Addendum 98: Regulation No. 99

Revision 2 – Amendment 2

Supplement 6 to the original version of the Regulation - Date of entry into force:
9 December 2010

Uniform provisions concerning the approval of gas-discharge light sources for use in approved gas-discharge lamp units of power-driven vehicles

Sheet DxR/1

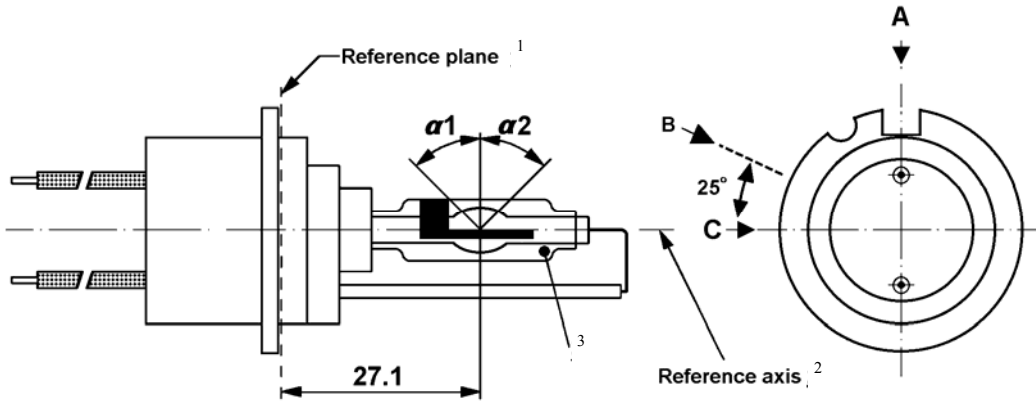
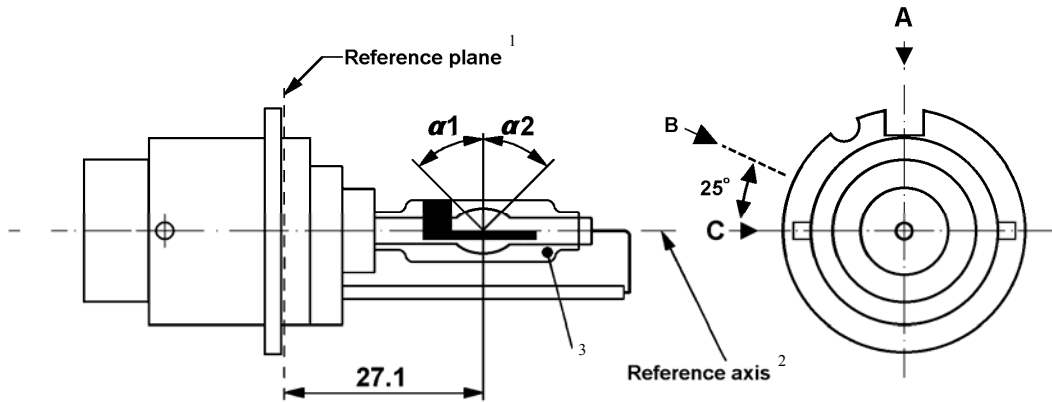
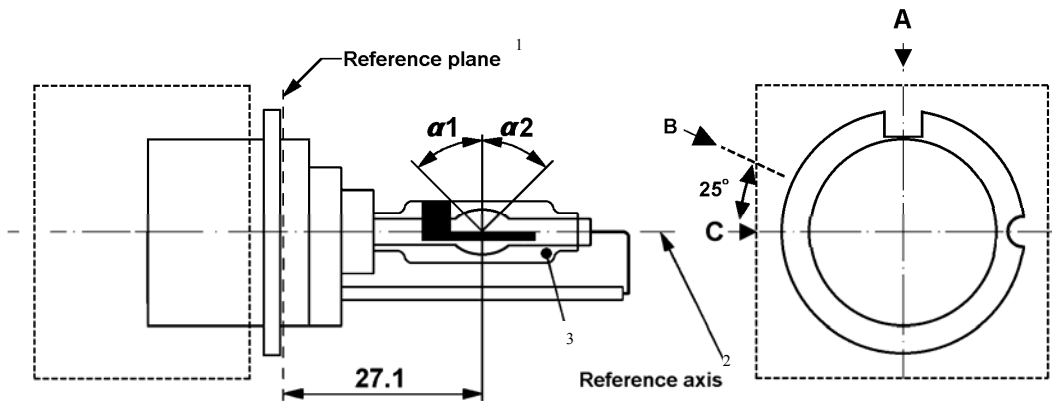
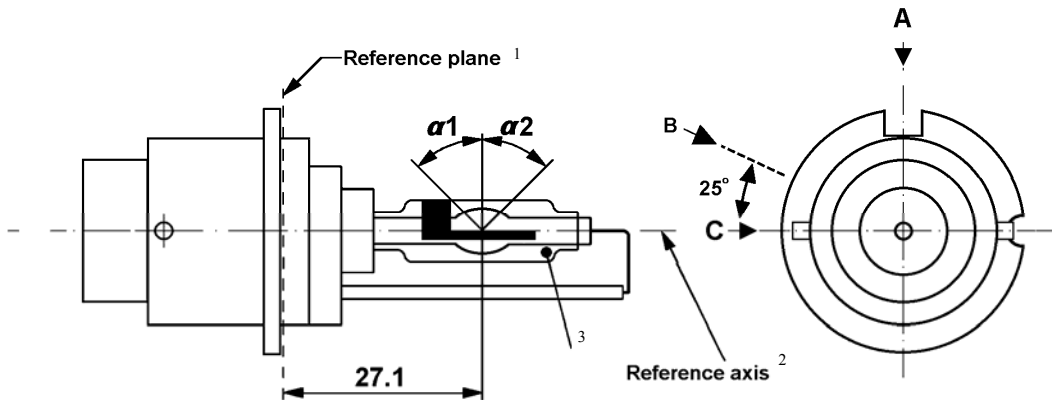
Sheets DxR/1 to 3 and DxR/6, replace by new sheets, to read (see next pages):

³ With respect to the reference axis, when measured at a distance of 27.1 mm from the reference plane the eccentricity of the outer bulb shall be less than ± 0.5 mm in direction C and less than -1 mm / $+0.5$ mm in direction A.

Sheet DxS/2

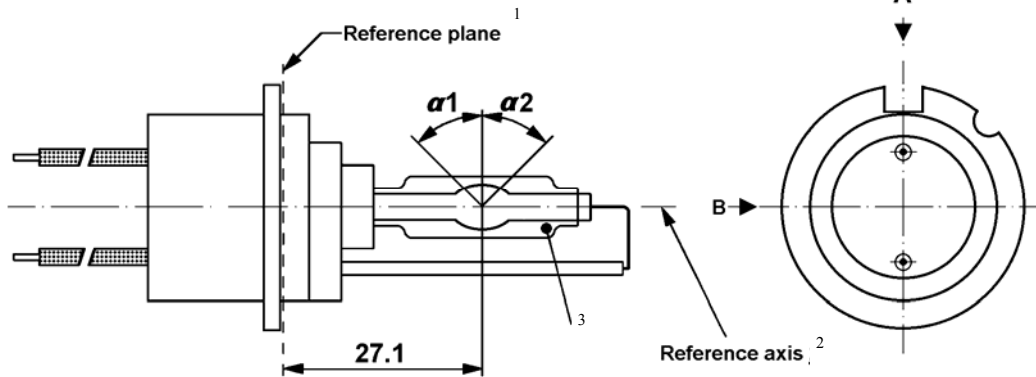
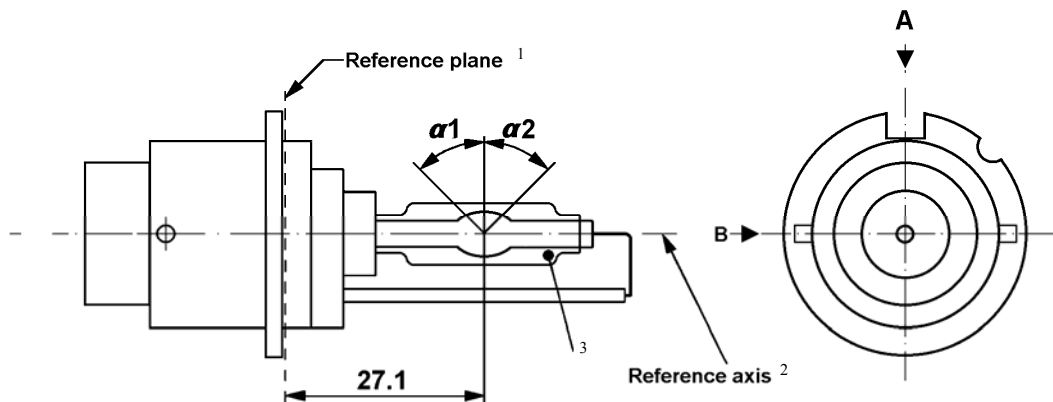
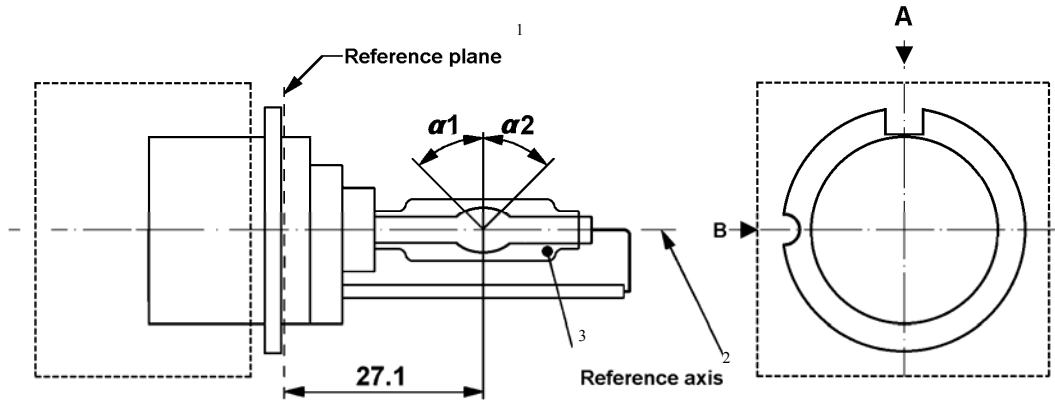
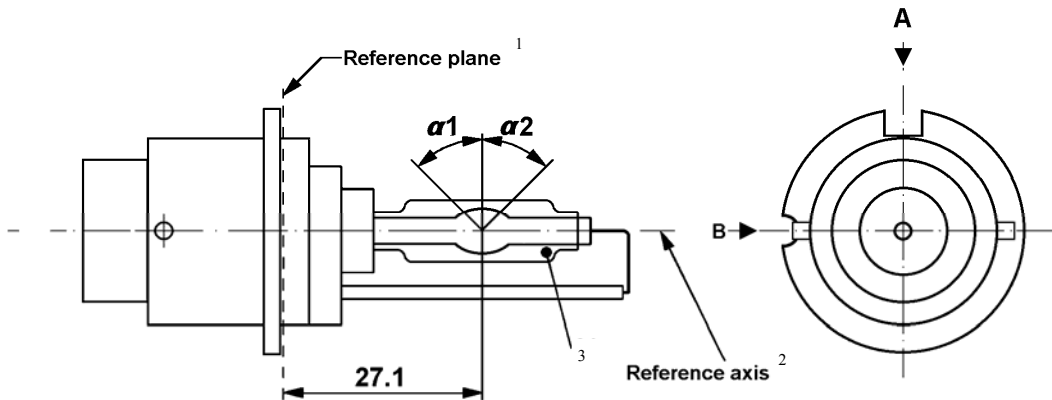
Sheets DxS/1 to 3 and DxS/6, replace by new sheets, to read (see next pages):

³ When measured at a distance of 27.1 mm from the reference plane and with respect to the mid-point of the inner bulb, the outer bulb shall have an eccentricity of 1 mm max.

³ When measured at a distance of 27.1 mm from the reference plane and with respect to the mid-point of the inner bulb, the outer bulb shall have an eccentricity of 1 mm max.
